**re: Geotechnical Review of Grading Plan
Proposed Commercial Development**
801 Eagleson Road – Ottawa, Ontario

file: PG2574-MEMO.04

- Project No. 148792 – Grading Plan – Sheet Number C-200 – Issue No. 3 dated July 9, 2025.

FIGURE 2 - Paterson Markups for Lightweight Fill
PG2574-MEMO.04 dated July 29, 2025

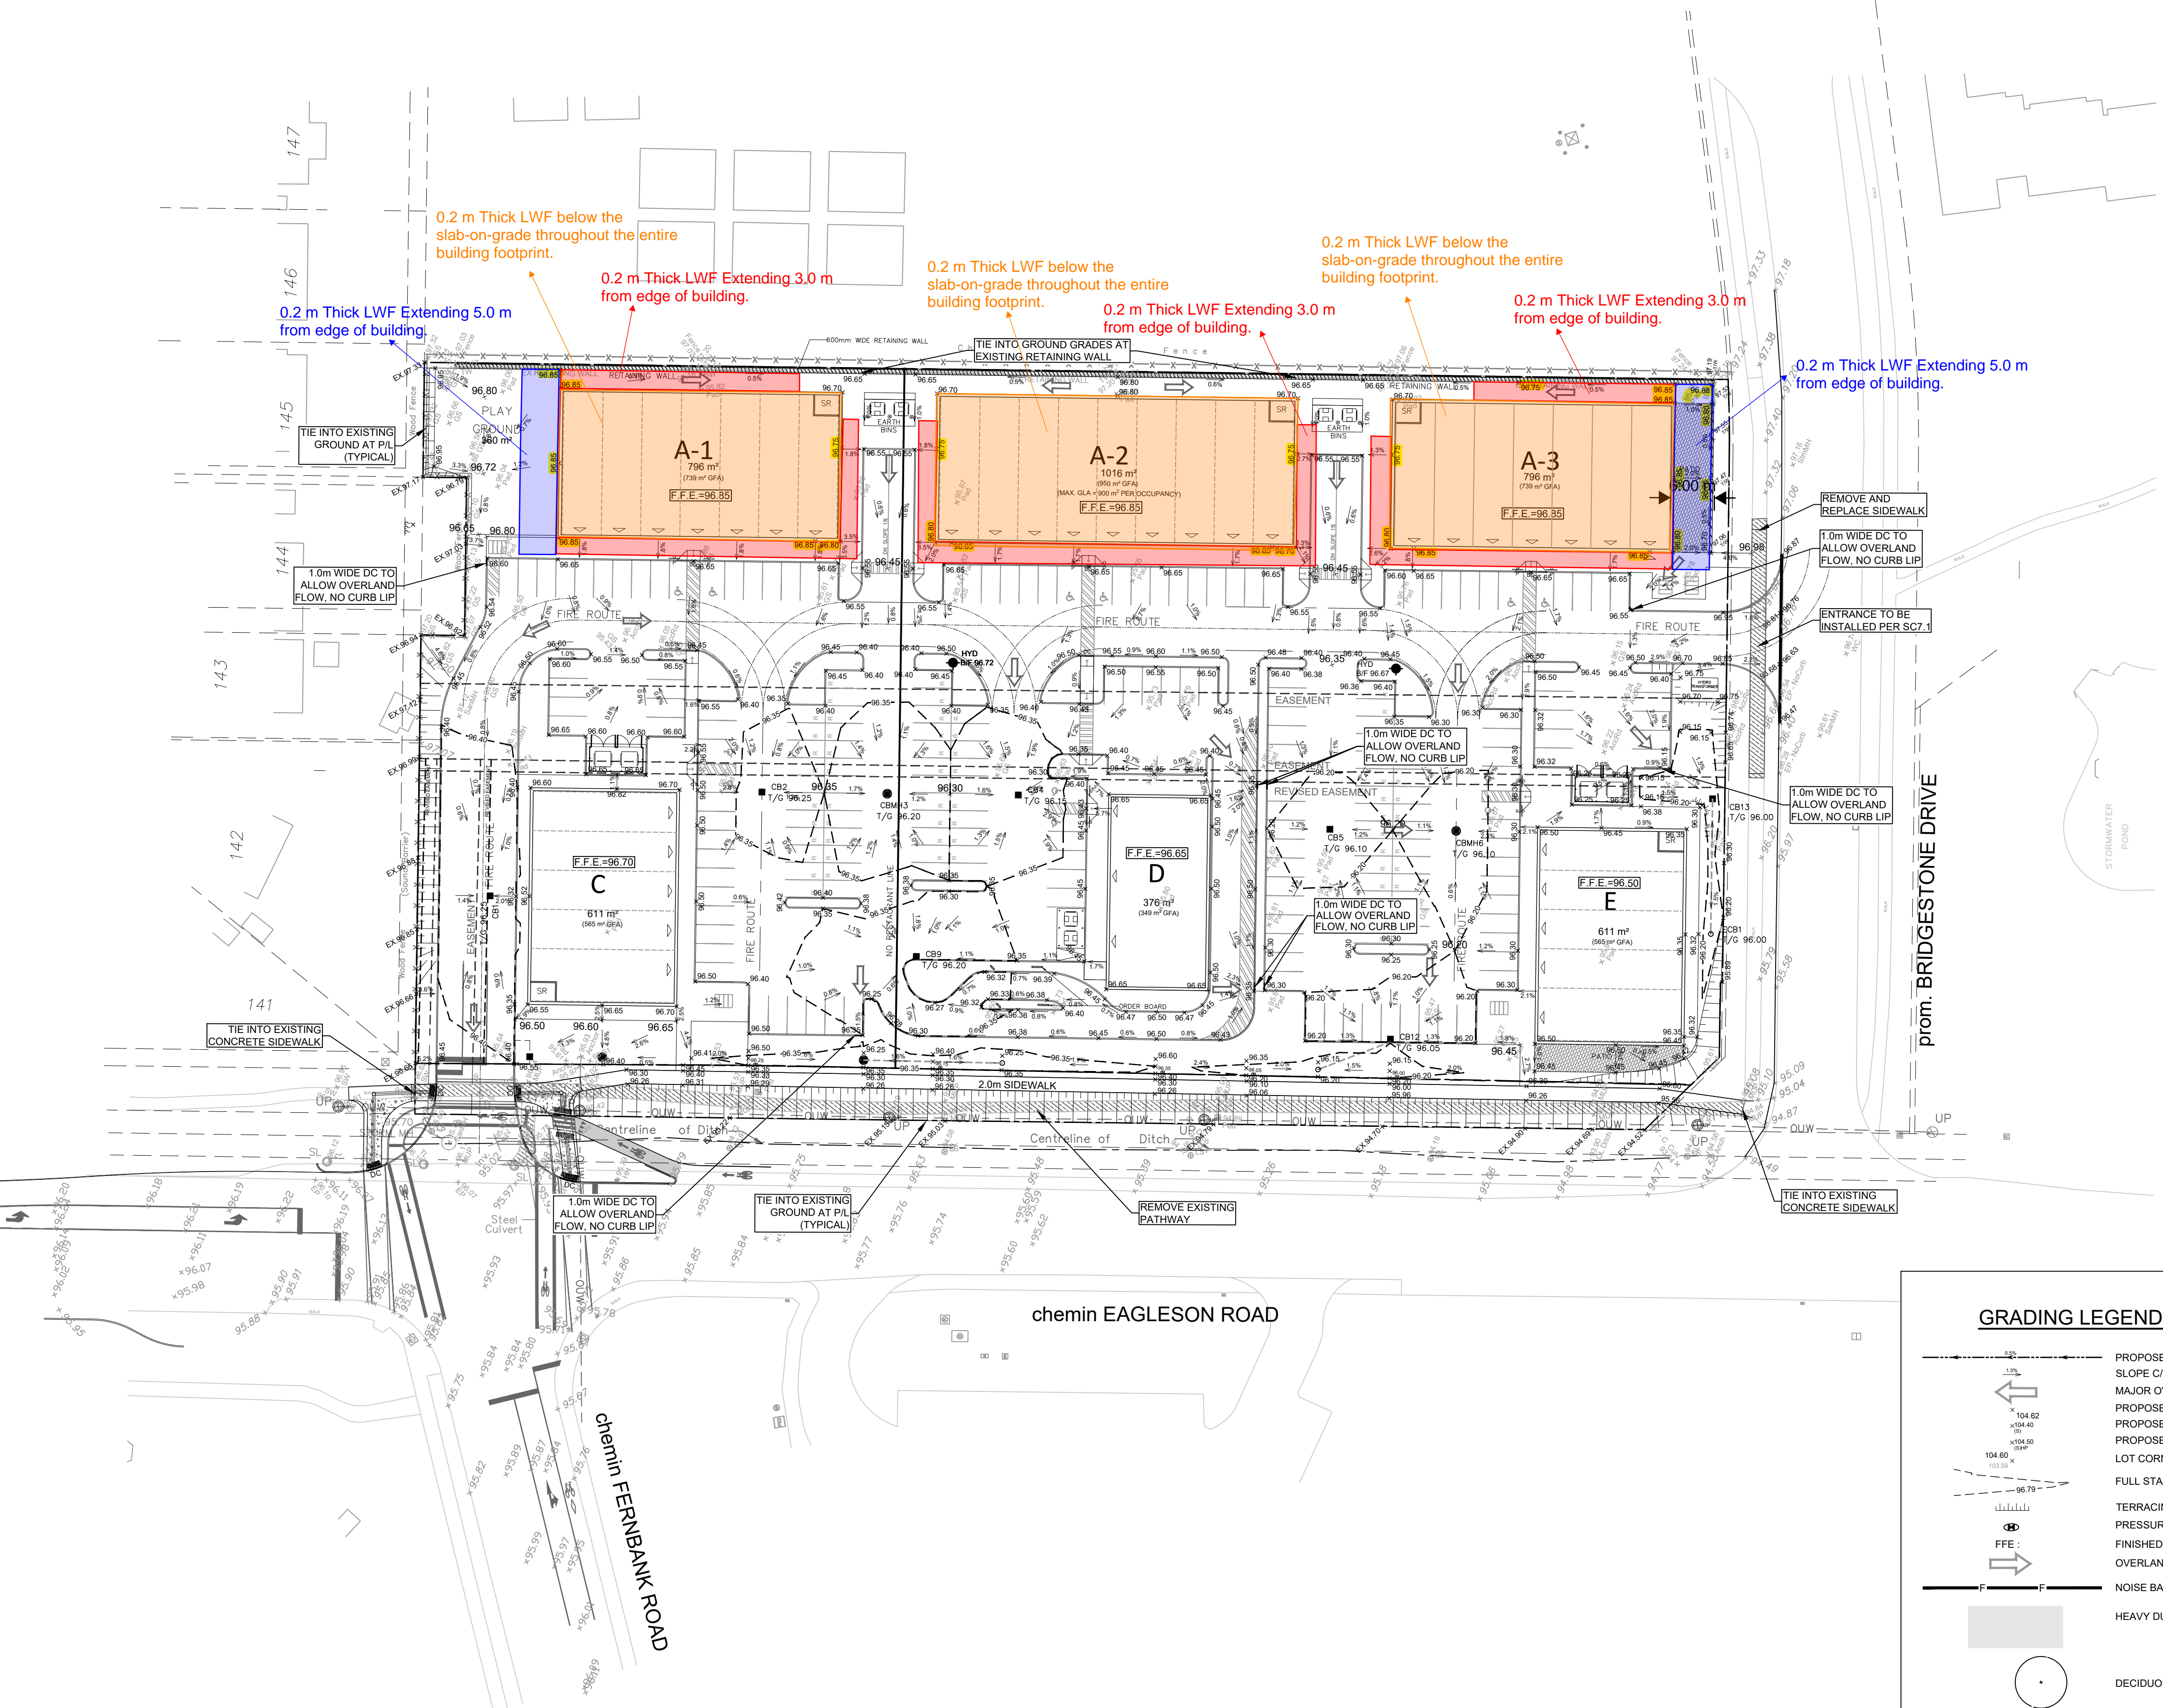
Based on our review, the proposed grading for the subject site is generally within the permissible grade raise recommendations provided in the geotechnical report with the exception of portions of Buildings A-1 to A-3, within the northern half of the property. Where localized grade raise exceedances are proposed, placement of lightweight fill (LWF), such as expanded polystyrene (EPS) geofoam blocks, is recommended below the floor slab and for areas adjacent to the subject commercial buildings. Reference should be made to Figure 2 – Markups for Lightweight Fill Placement, attached to this memorandum, for the recommended thicknesses and extents of LWF for the subject buildings.
